13-980106-CLN-01

TO: DISTRIBUTION
FROM: C NEUMEYER
SUBJECT: REWORK OF TF BUNDLE OUTER LAYER TURN TO TURN INTERFACE REGION

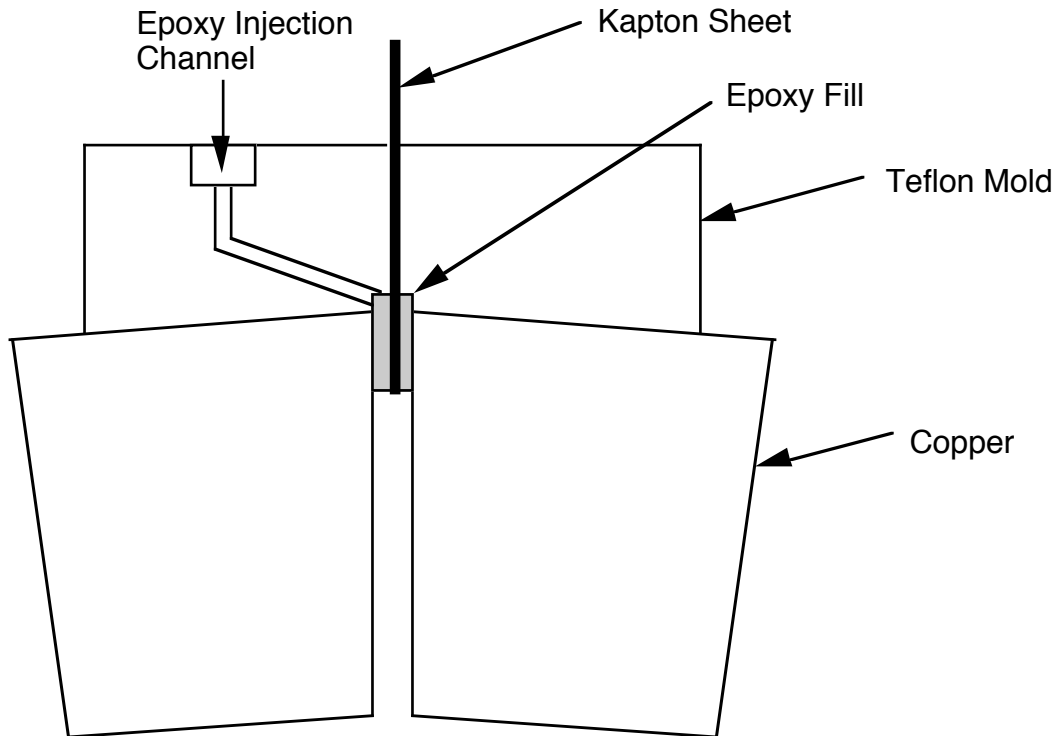
3) The silicone gasket technique, with which a bevel will be machined on to the edges of the lead flags to accommodate the gasket which would be compressed to form a turn to turn seal after attachment of the flag.

Disadvantage: Loss of contact area; lack of continuous kapton barrier; re-design.

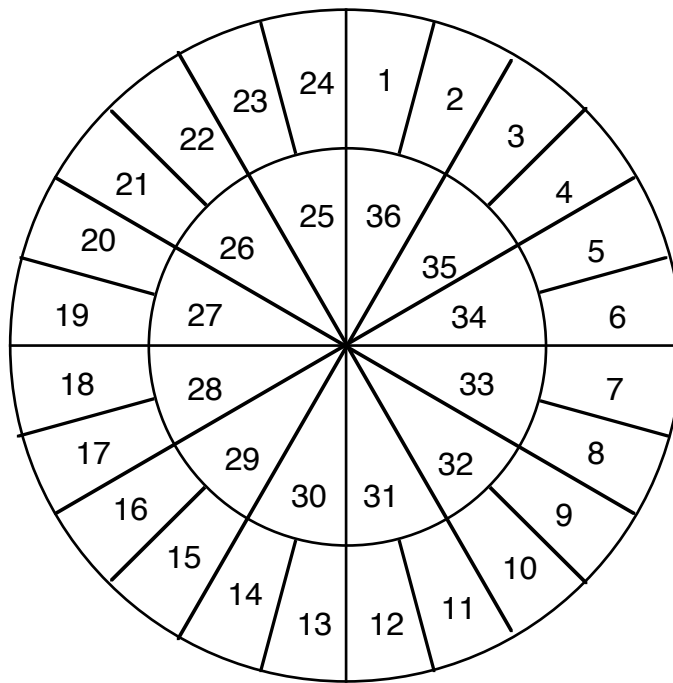
As a matter of additional information, the following shows the winding pattern of the inner leg bundle. As can be seen the voltage between adjacent turns on the outer layer is simply the voltage per turn ($1012.85/36 = 28$ volts) except for the location where turns 1 and 24 face each other ($24 * 28 = 672$ volts). Clearly it is important to position the more robust quadrant to quadrant gap at this location in the winding pattern.

One could argue that at $28/64 \approx 0.5$ volt/mil in the turn to turn gap there is simply no concern and no need for the kapton fins. However, I feel that in order to maintain the integrity of this gap in service with dirt/contamination/motion of parts, the fin remains an important element that we should not sacrifice.
